APPLICATION FOR PERMIT TO DRILL, DEEPEN, OR PLUG BACK

SUNDRY NOTICES AND REPORTS ON WELLS

8. FARM OR LEASE NAME
Hanks

9. WELL NO.
#25

SOUTHLAND ROYALTY COMPANY #25 HANKS
680' FNL 1880' FEL Sec. 6-T27N-R9W SAN JUAN COUNTY, NEW MEXICO

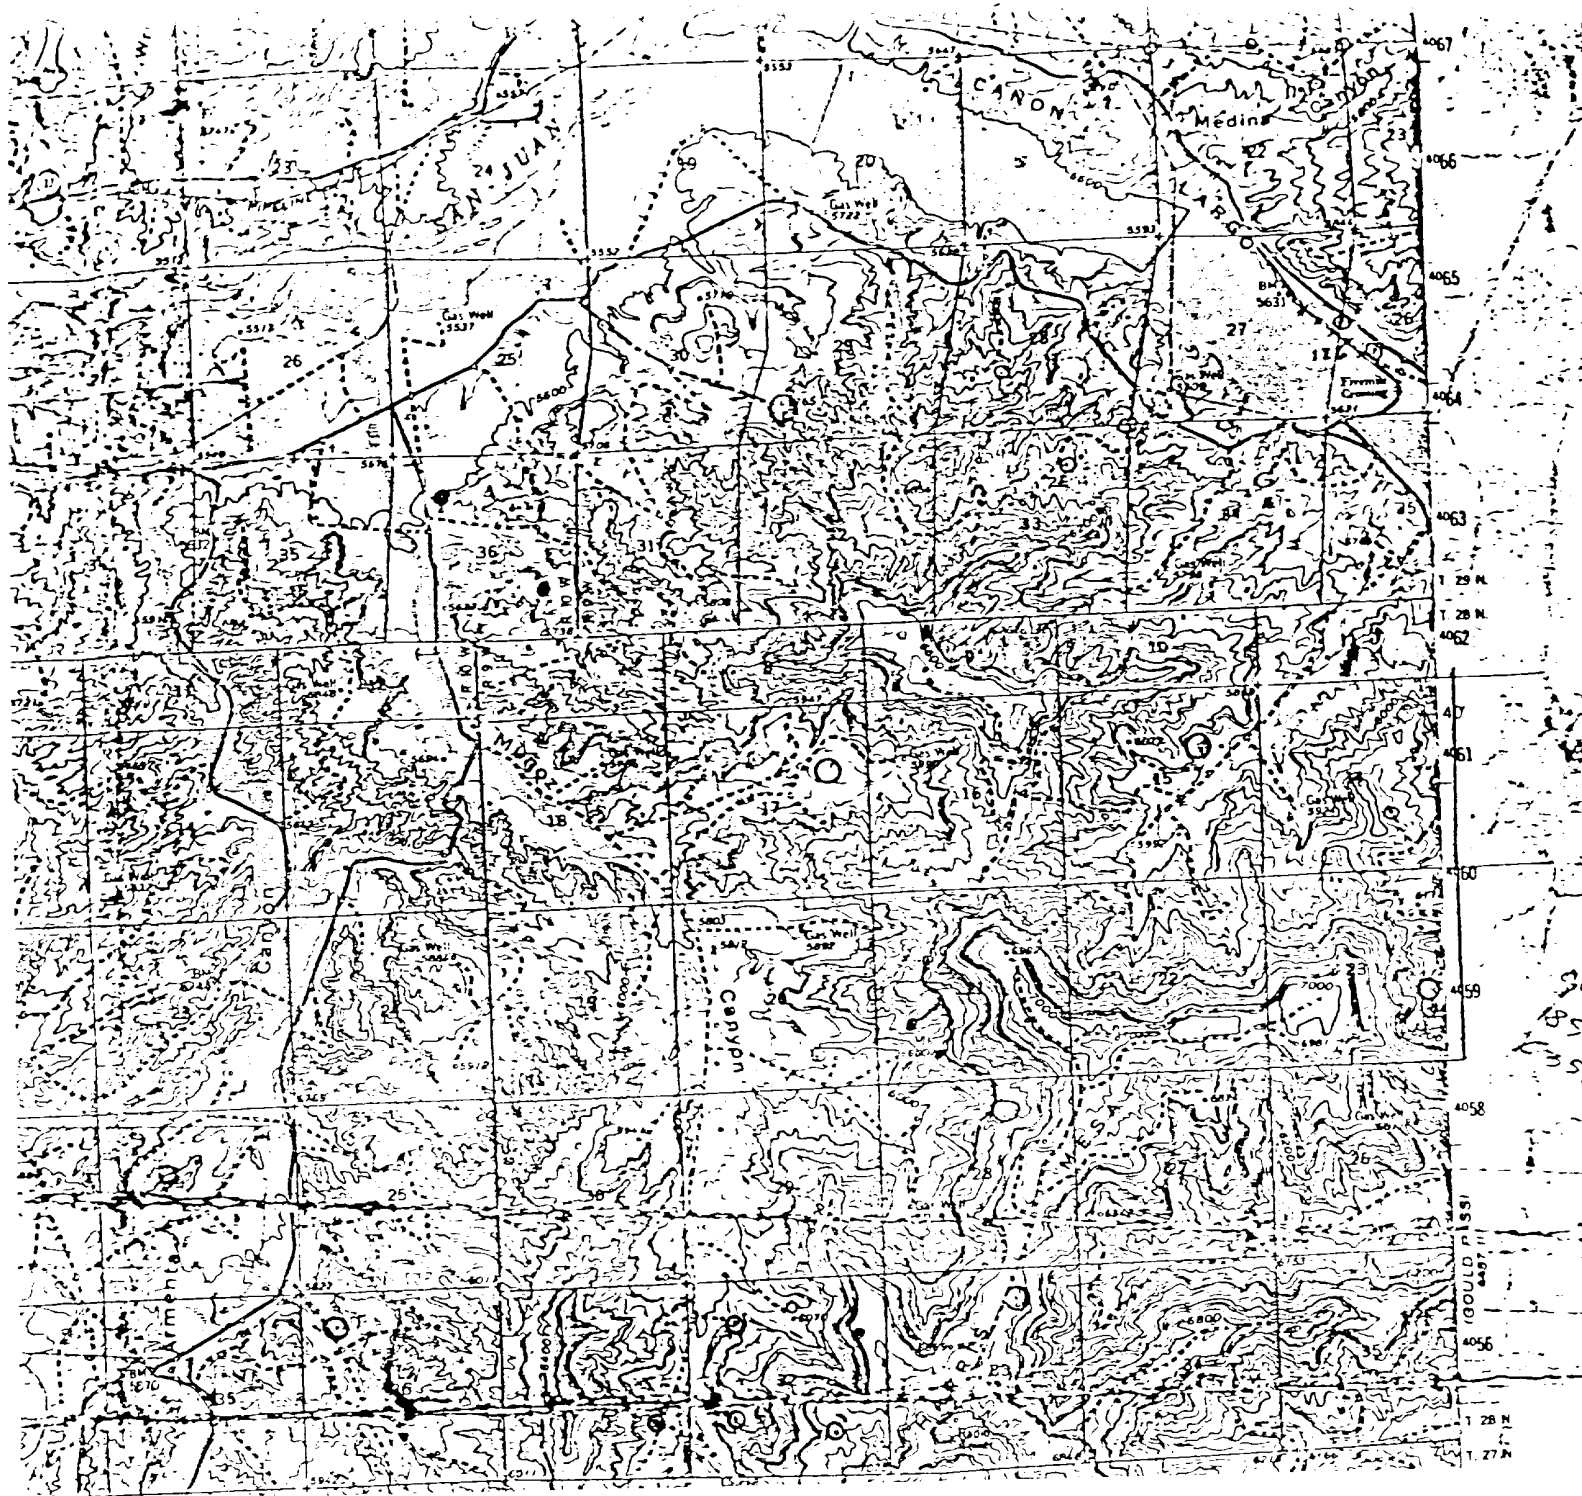
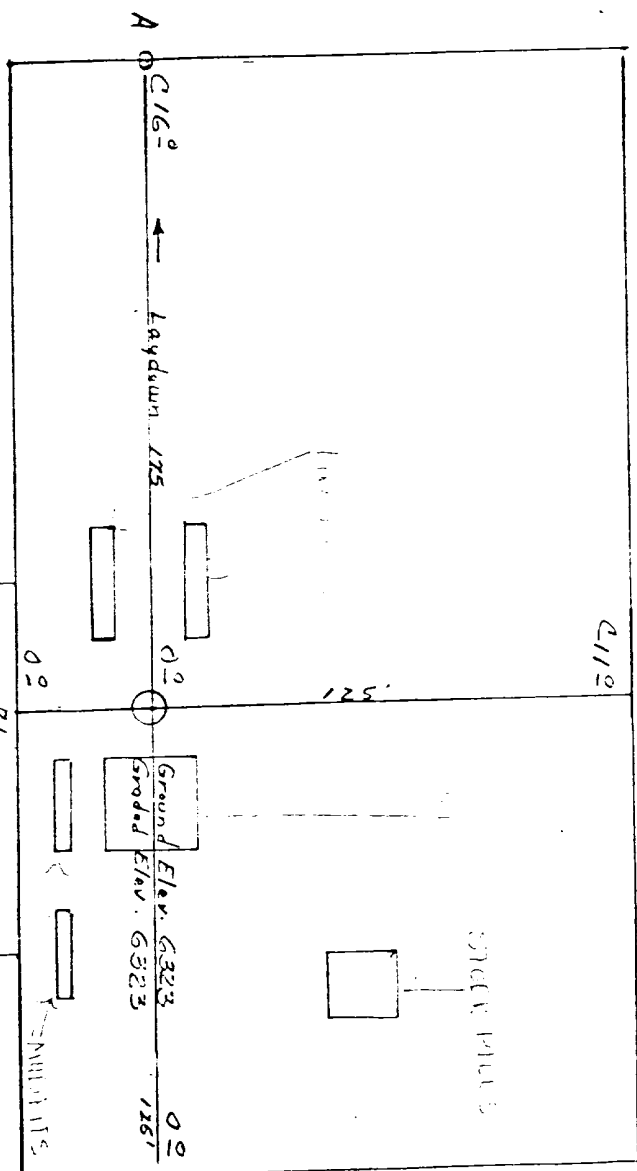
Southland Royalty Company proposes to move this wellsite from 990' FNL & 1000' FEL to 680' FNL & 1880' FEL, Section 6, T27N, R9W, San Juan County, New Mexico. This move is requested due to bad road conditions and radical terrain of original site.
